Addendum 5

May 8, 2026

**KINGS BRANCH AT ARROWOOD ROAD STREAM RESTORATION  
PHASE 2A  
MECKLENBURG COUNTY, NORTH CAROLINA**

**MODIFICATIONS TO THE CONSTRUCTION DRAWINGS**

**KINGS BRANCH AT ARROWOOD ROAD PHASE 2A**  
SHEET **C-9.1** OF **33**  
**EC-PLANS**

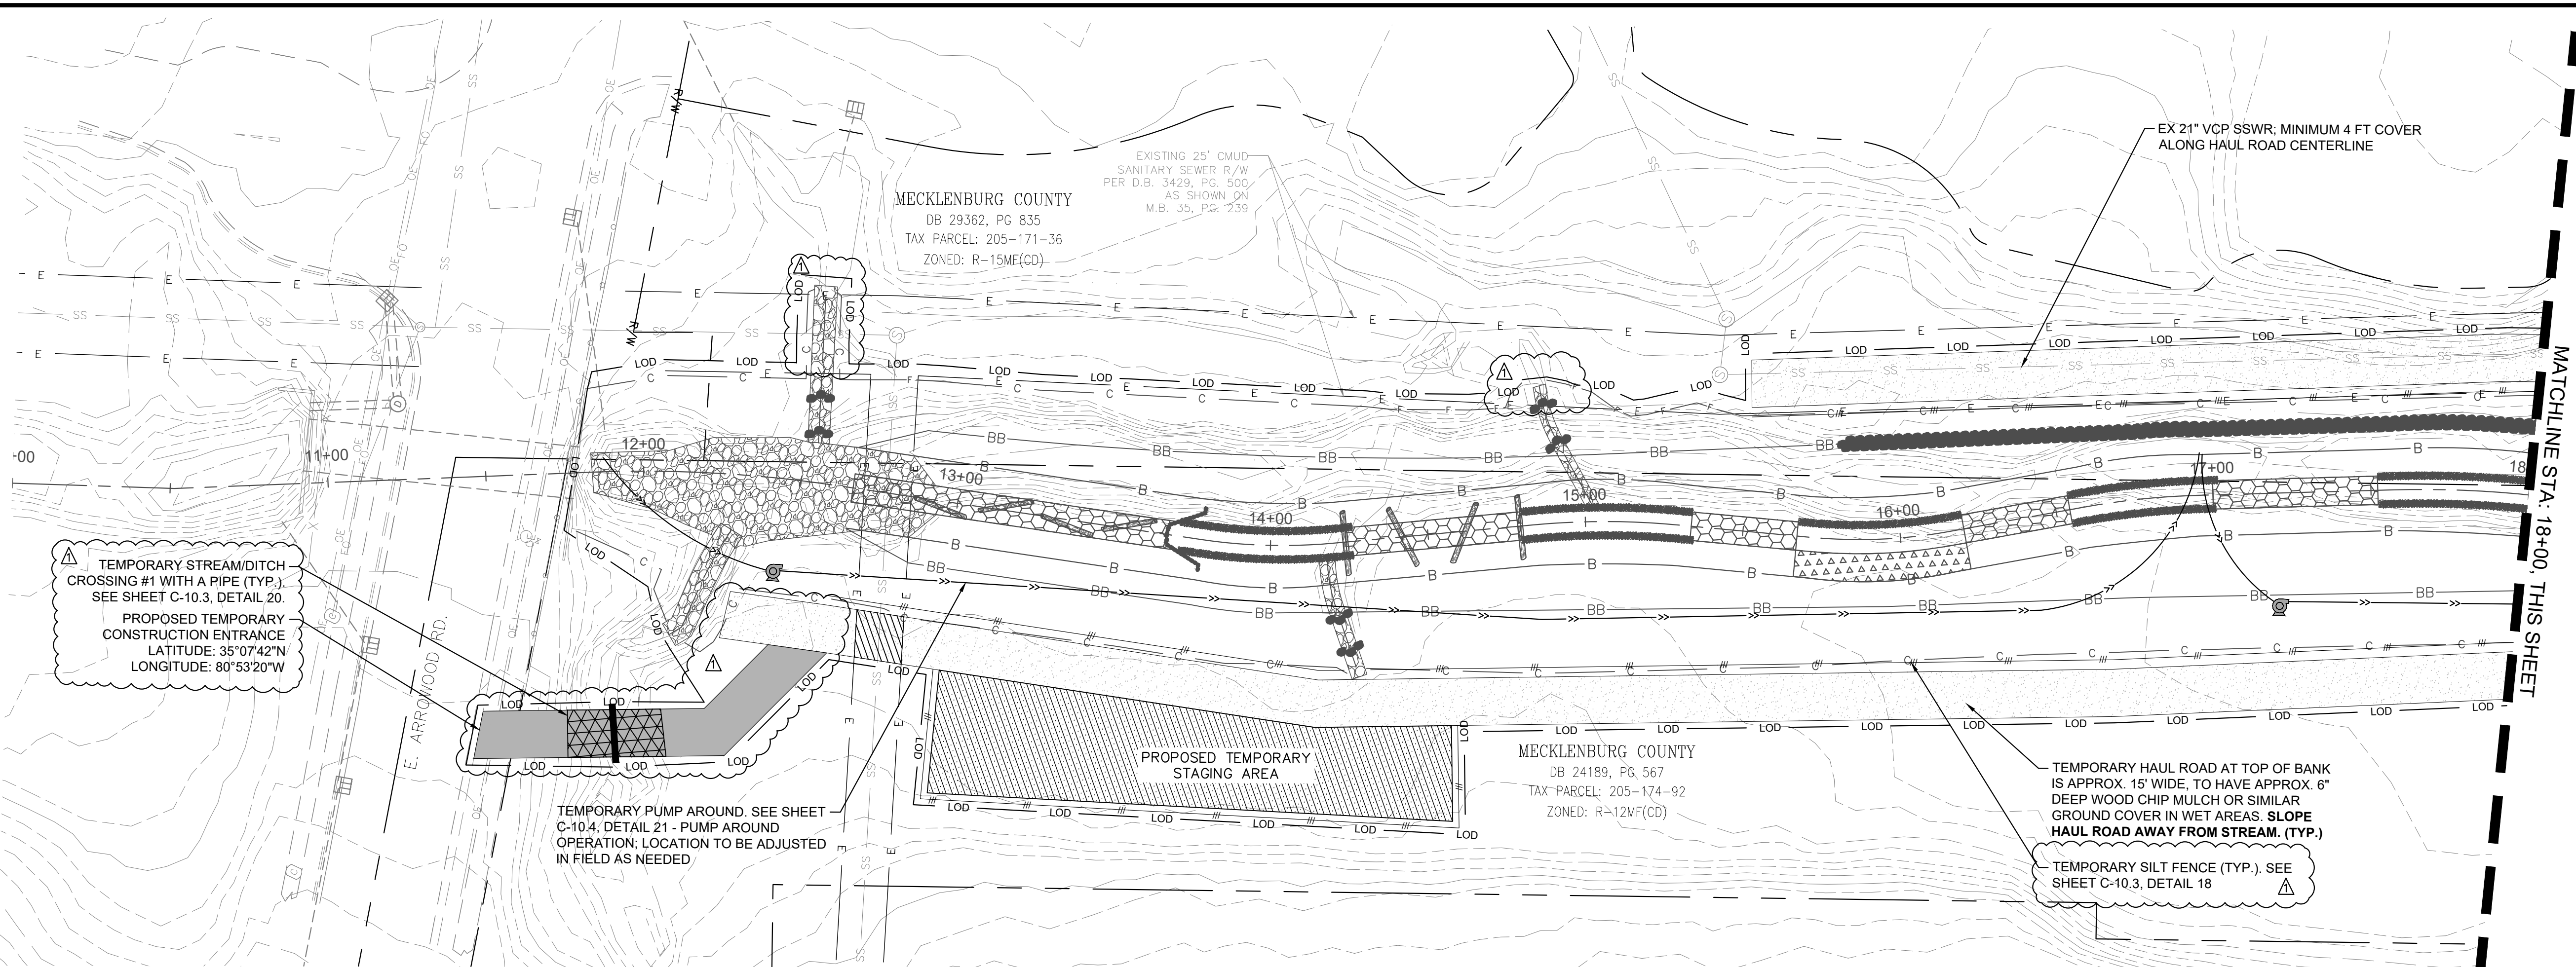
Sheet C-9.1:

- Construction entrance, LOD, and notes updated

SHEET **C-9.2** OF **33**

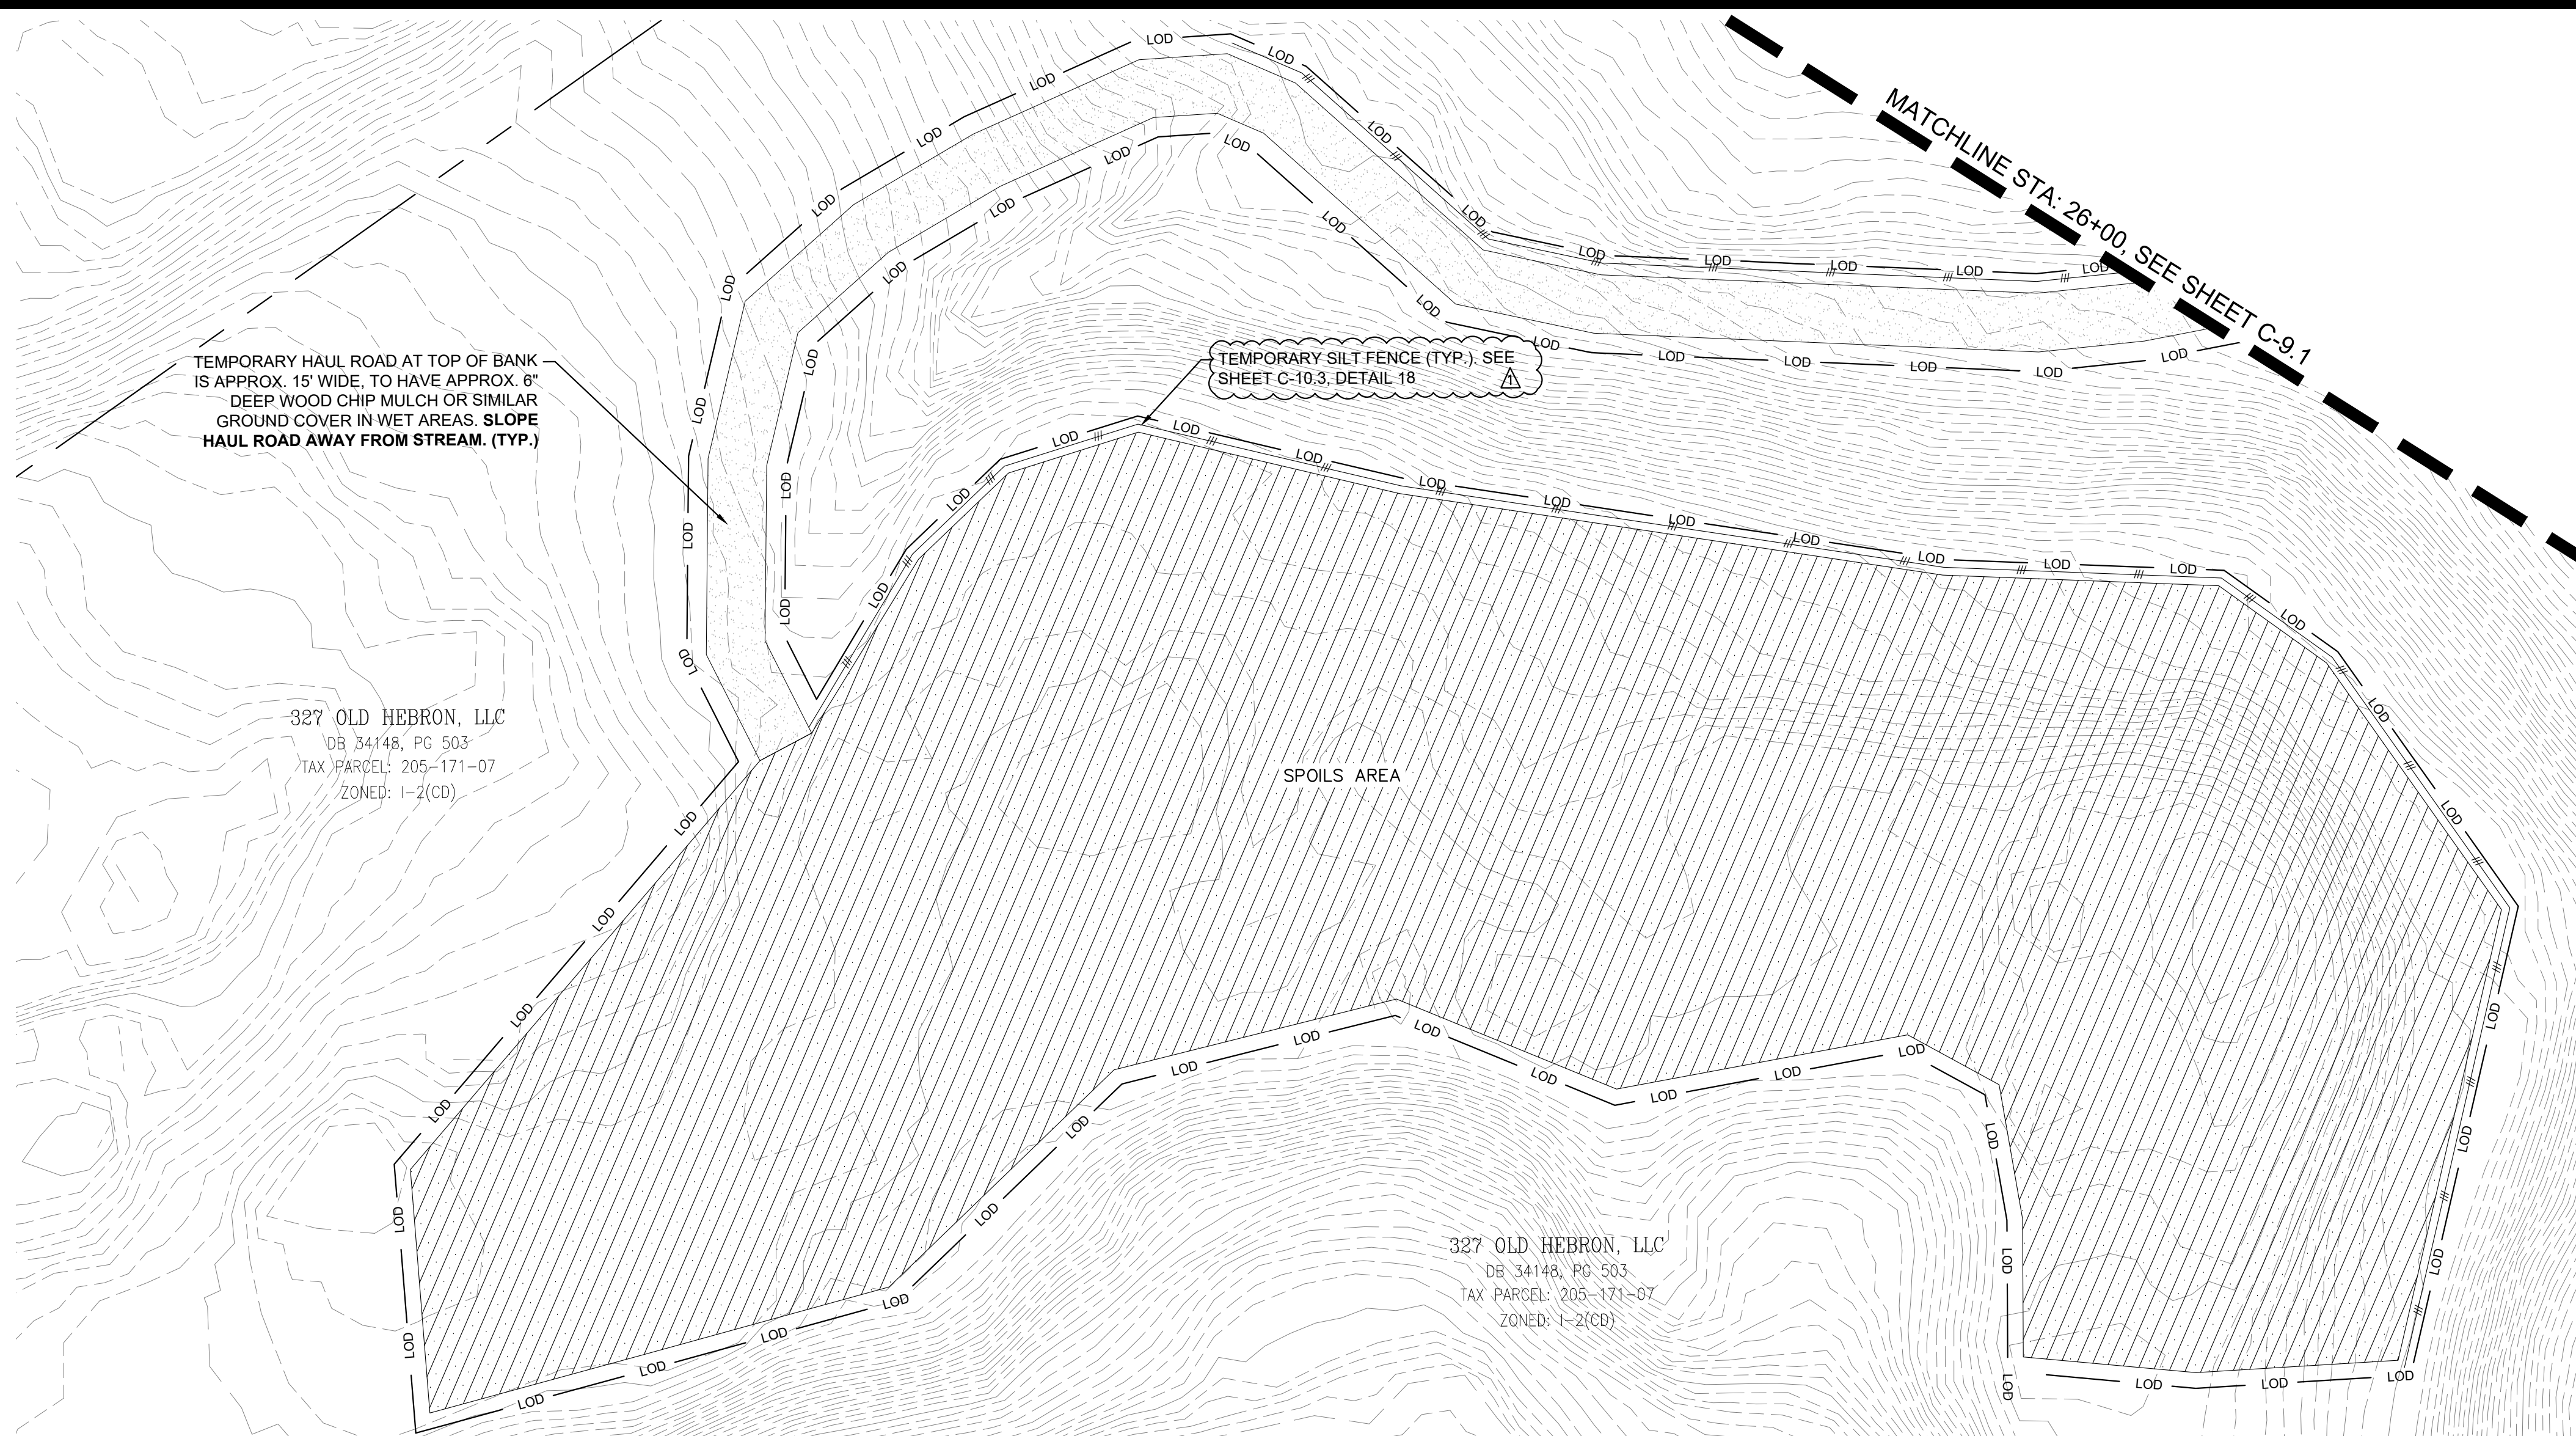
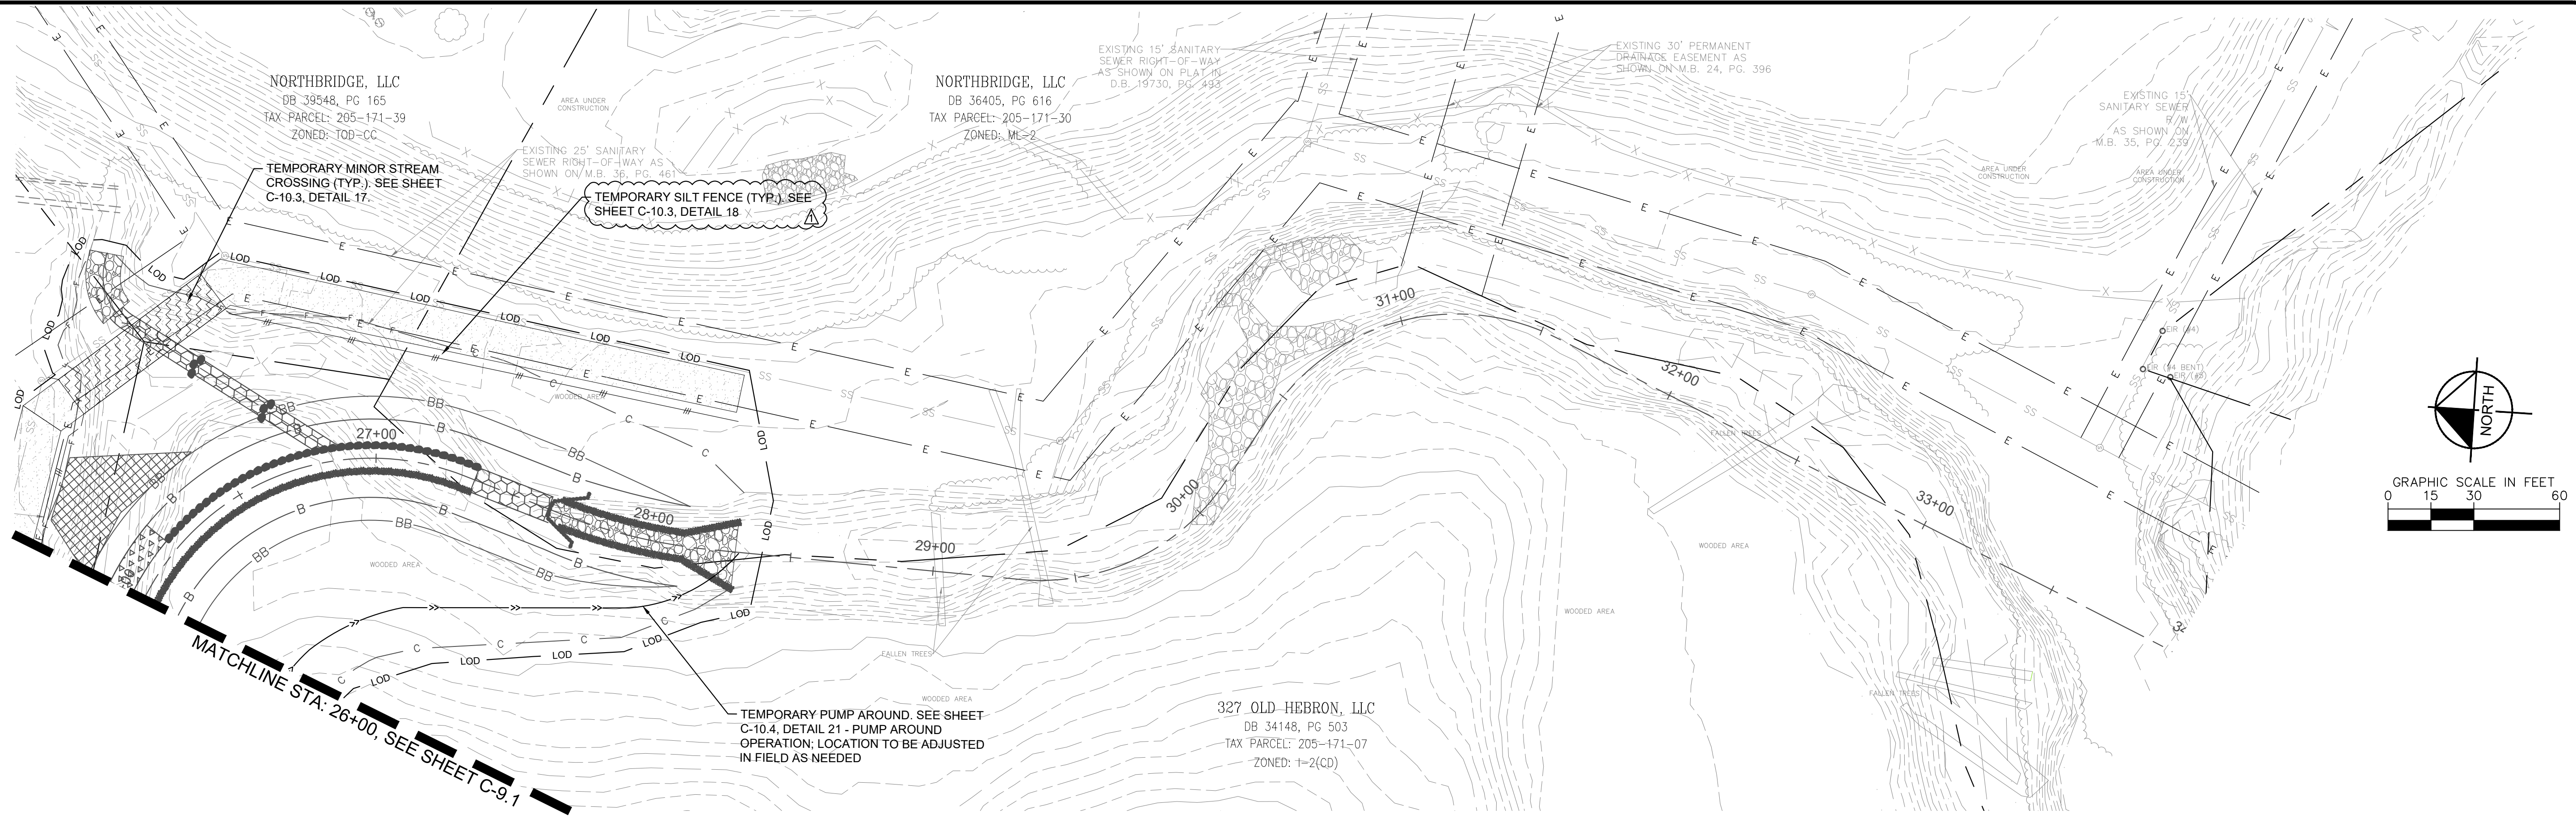
Sheet C-9.2:

- Updated notes

**20 TEMPORARY DITCH CROSSING WITH PIPE**

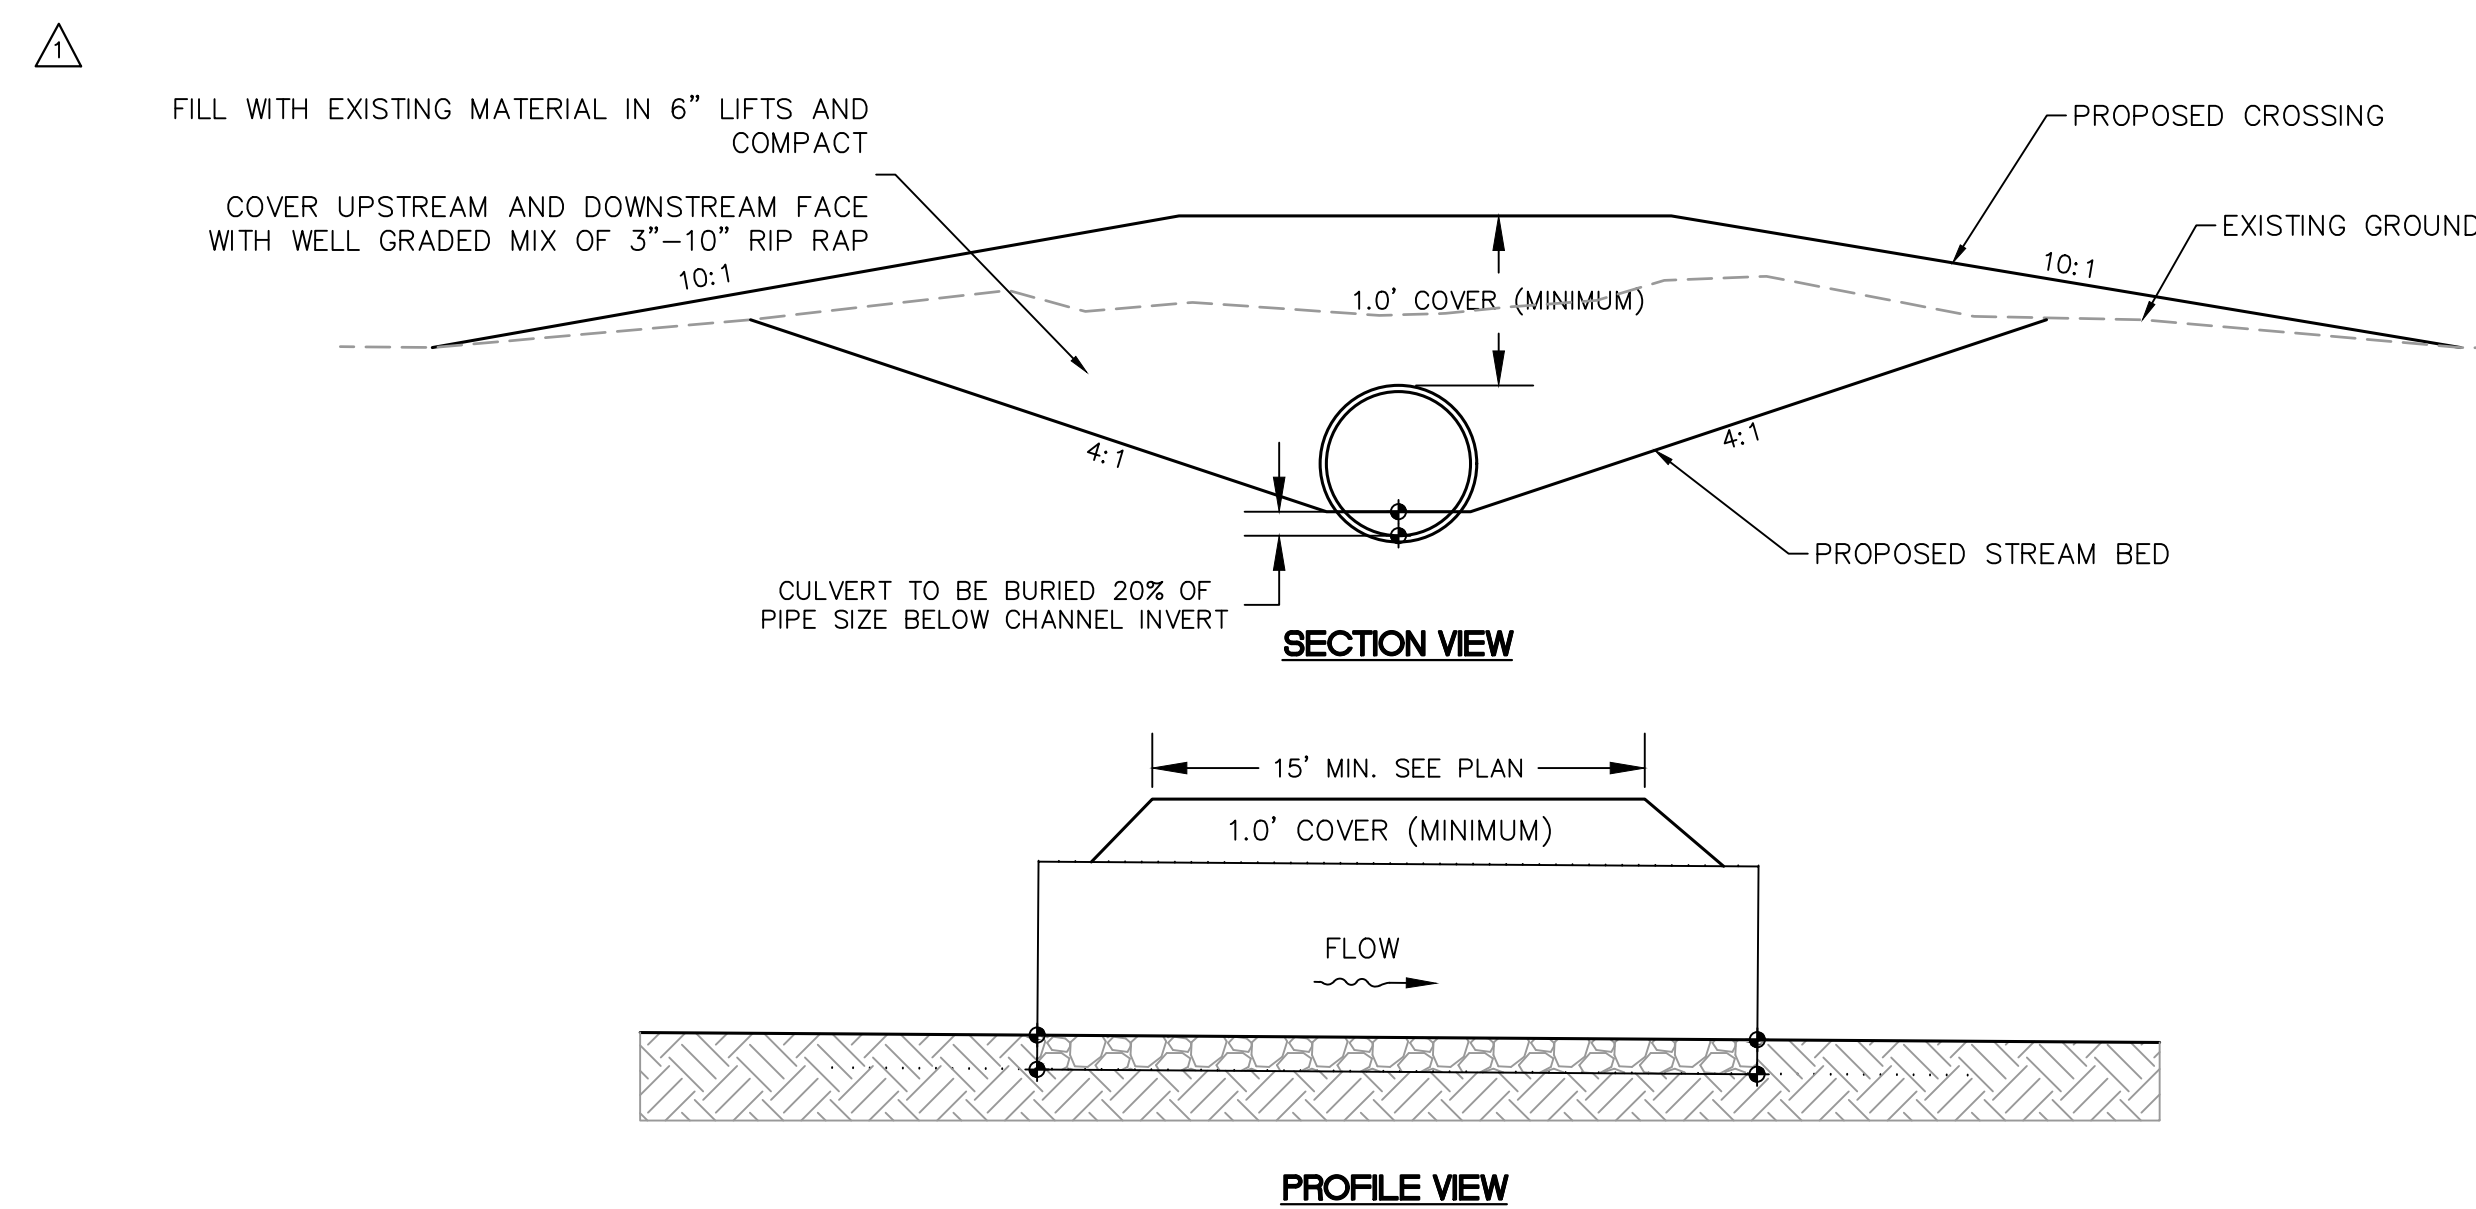
Sheet C-10.3:

- Temporary Ditch Crossing with Pipe detail updated to show no mitered/tapered ends

19. What size and type of pipe is required for the temporary ditch crossing?

**A 24" HDPE pipe can be used for the temporary ditch crossing. The pipe is incidental to temporary crossing.**
